**ADDENDUM #1**

**HOSPITALITY MANAGEMENT BUILDING  
RENOVATION AND EXPANSION**

**BID #10-0910**

**MISSION COLLEGE**

147. The location of the staging area for the project has been identified; see attached sketch entitled "**Project Staging Area Plan**"

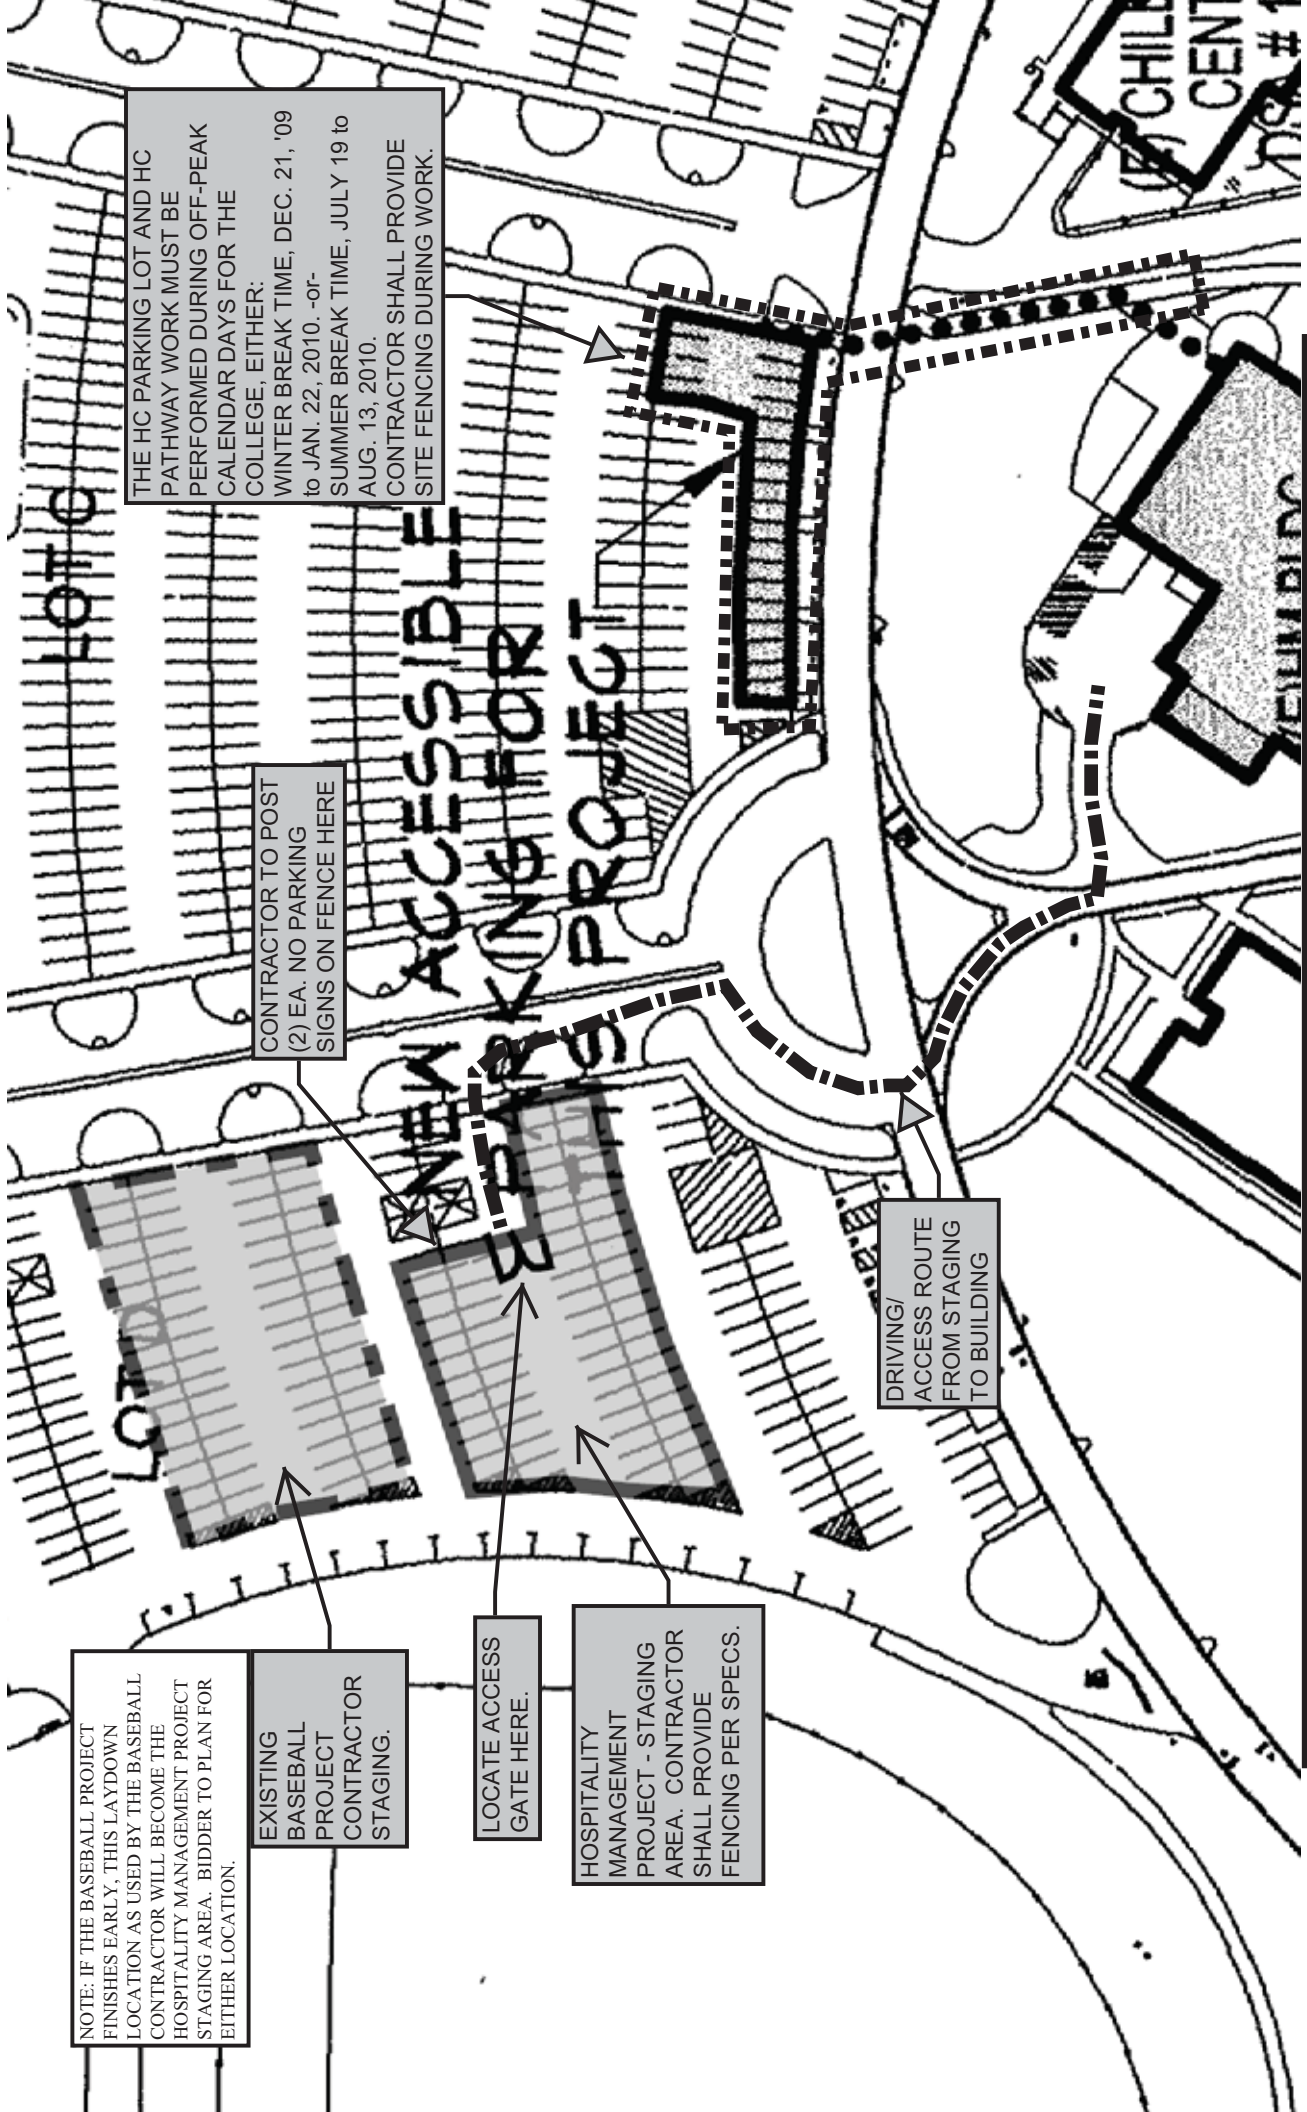
NOTE: IF THE BASEBALL PROJECT FINISHES EARLY, THIS LAYDOWN LOCATION AS USED BY THE BASEBALL CONTRACTOR WILL BECOME THE HOSPITALITY MANAGEMENT PROJECT STAGING AREA. BIDDER TO PLAN FOR EITHER LOCATION.

EXISTING BASEBALL PROJECT CONTRACTOR STAGING.

LOCATE ACCESS GATE HERE.

HOSPITALITY MANAGEMENT PROJECT - STAGING AREA. CONTRACTOR SHALL PROVIDE FENCING PER SPECS.
